SIB 61 21 19

SERVICE ACTION: INSPECT AND REWORK ENGINE COMPARTMENT WIRING HARNESS

E-Series	Model Description	Production Date
G20	3 Series Sedan	October 24 th , 2018 – March 19 th , 2019

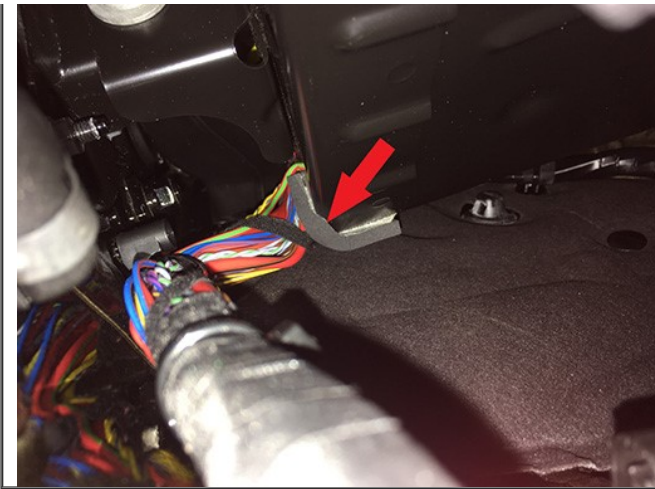
Check the wiring harness in the marked area for damage and repair as described below.

2. If no damage is found, as shown on the picture, proceed to **Step 3**.

3. Wrap the wiring harness cable with abrasion protection hose, and secure it with cable straps.

- Relocate the wiring harness by pushing it towards the body, to provide better clearance.

- Install a foam pad on the lower left front corner (arrow) of the battery holder.

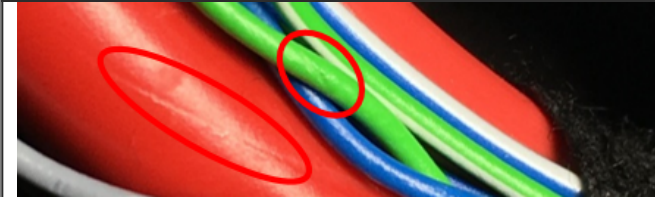
- Foam shown properly installed on the vehicle, by looking down the front left side of the battery holder, next to the wiring harness.

NO FURTHER ACTION NEEDED.

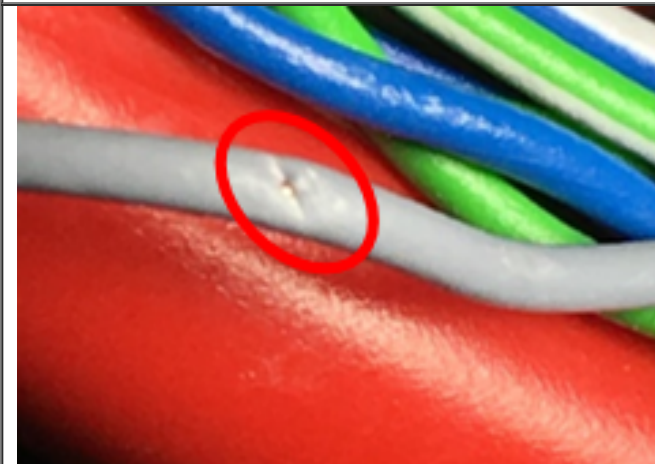
4. If wiring harness insulation shows damaged/ chafe marks visible on insulation, but no copper strands are visible.

- Wrap the damaged single strand with insulating tape, and perform **Step 3**.
